Product/Process Change Notice (PCN)

PCN #: WE_UNIT_20150619

Product Affected: WE-UNIT 750370024,
750871033, 750811024, 7508110104,
7508110107

| Before change | After change |
|--|---|
|  <p data-bbox="204 1809 379 1843">Bottom view</p>  |  <p data-bbox="721 1809 896 1843">Bottom view</p>  |

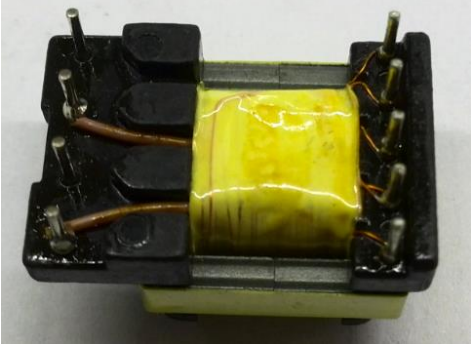
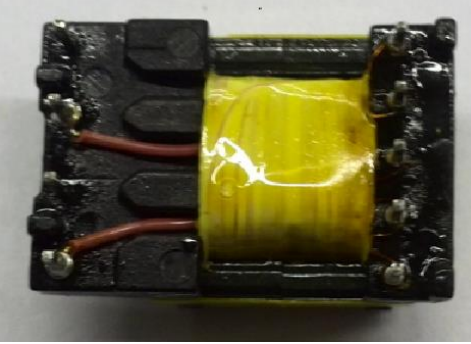
To improve the processability Würth Elektronik will change the bobbin to a bobbin with improved slots for wire routing and improved stand offs. Therefore dimensions will slightly change.
